SAFETY EVALUATION BY THE OFFICE OF NUCLEAR REACTOR REGULATION

REGARDING CORE SHROUD WELD EXAMINATIONS DURING THE

1998 REFUELING OUTAGE AND ASSOCIATED FLAW EVALUATIONS

NINE MILE POINT NUCLEAR STATION, UNIT NO. 2

Figure 1-1 Weld Designations Used in NMP2 Shroud Cracking Evaluation (Weld azimuths are typical, and may not be located exactly as specified in above figure)

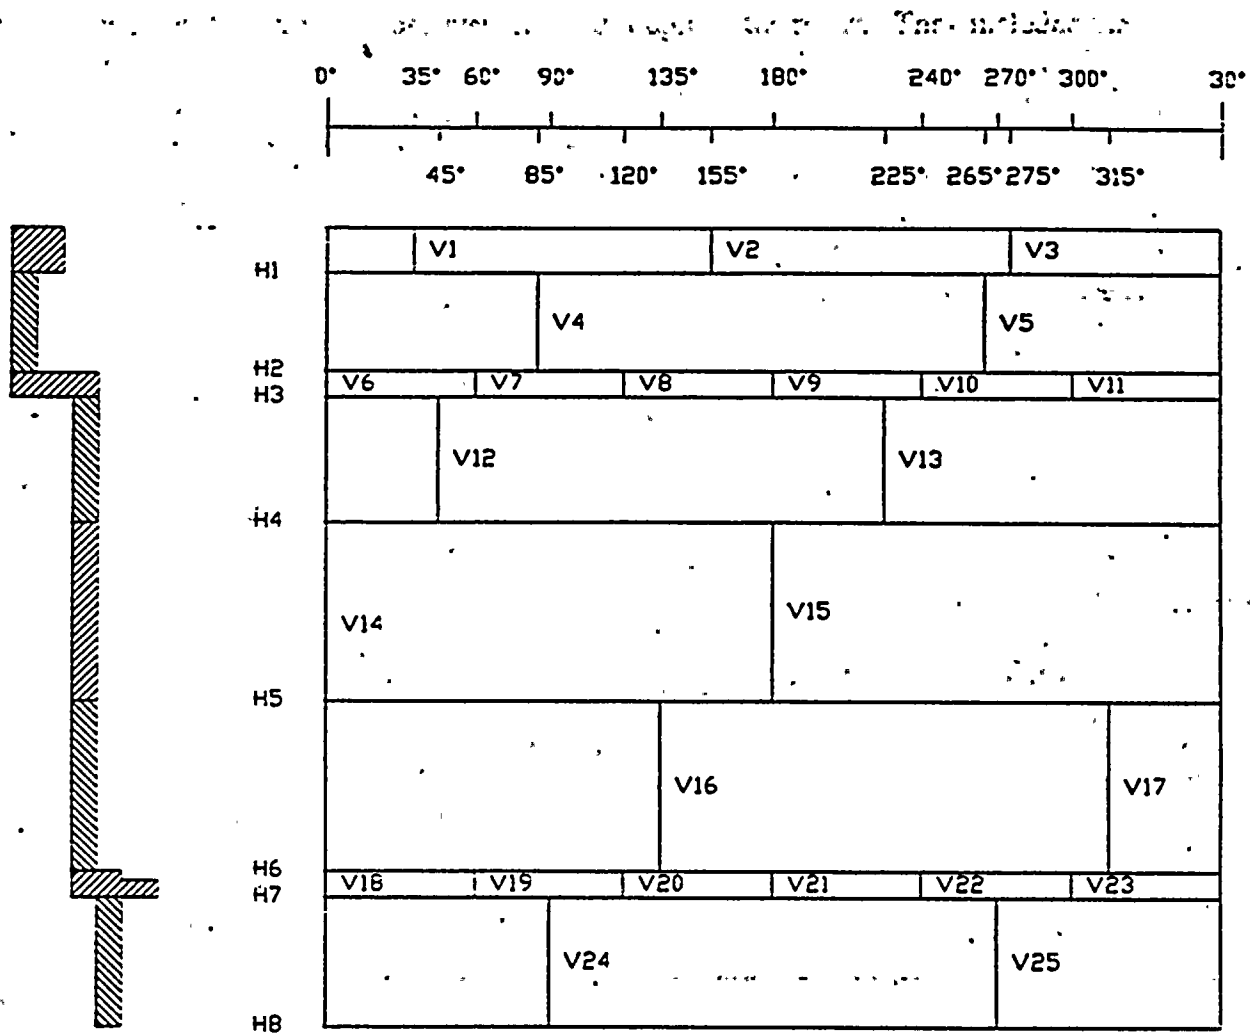
The NMP2 shroud material is SA-240 Type 304L plate. The shroud thickness is 2 inches. Weld designations are shown in attached Figure 1-1 (extracted from NMPC's submittal dated July 9, 1998).

Since no flaw indications were found in the vertical welds, NMPC only evaluated the detected circumferential flaws in the horizontal welds. NMPC applied limit load analysis to all eight horizontal welds. The limit load analysis is consistent with that of Appendix C of Section XI of the American Society of Mechanical Engineers Boiler and Pressure Vessel Code (ASME Code). The results indicated that for the limiting weld, H4, the calculated safety factor is 5.13, which exceeds the ASME Code's required value of 2.77 by a significant margin.

To account for the effect of embrittlement on three (H3, H4, and H5) of the eight welds in the beltline region (with estimated peak fluence greater than 3×10^{20} n/cm²), NMPC also applied the linear elastic fracture mechanics (LEFM) methodology consistent with the methodology in the report by the Boiling Water Reactor Vessel and Internals Project, BWRVIP-01, Revision 1, "BWR Core Shroud Inspection and Flaw Evaluation Guidelines," dated March 1995 (also referred to as GENE-523-113-0894, Rev. 1) to horizontal welds H3, H4, and H5. The LEFM methodology
